Chapter 3
Responses to Comments

This chapter includes responses for each of the numbered comments identified in the comment letters in Chapter 2, Comments Received on the Draft EIR. Each response begins with a brief summary of the comment, responds to the comment, and then identifies if revisions to the Draft EIR are required. Revisions are included in Chapter 4, Revisions to the Draft EIR.

26 Comment 18-30

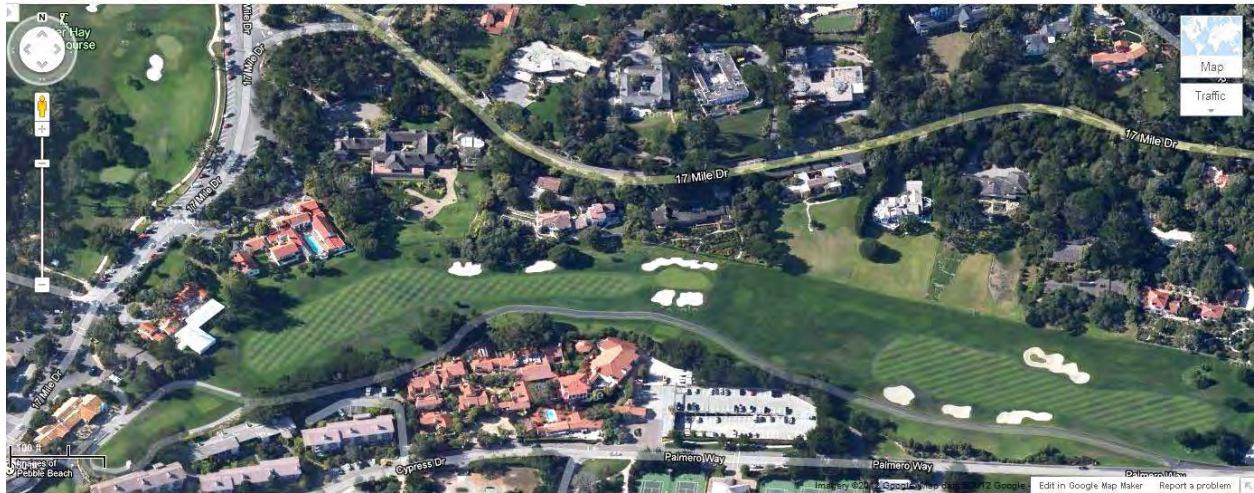
27 The commenter asserts that the Fairway One Complex would have adverse effects on human health
28 due to noise, light pollution, and vehicle emissions, that these impacts are substantially adverse and
29 thus potentially significant, and that the mitigation measures noted in comments 18-26, 18-27, 18-
30 28, and 18-29 should be evaluated to reduce these potentially significant impacts.

31 Refer to responses to Comments 18-26, 18-27 and 18-29. The noise levels would be within
32 acceptable levels along 17-Mile Drive adjacent to Fairway One and 3310 17-Mile Drive (and adjacent
33 residences) per the General Plan and Noise Ordinance, thus avoiding significant health impacts due
34 to noise. The vehicle emissions would not result in significant health impacts concerning air quality
35 along 17-Mile Drive at the location of concern. Light and glare impacts related to the Fairway One
36 Complex and significant light pollution for the adjacent residences would be less than significant
37 with mitigation.
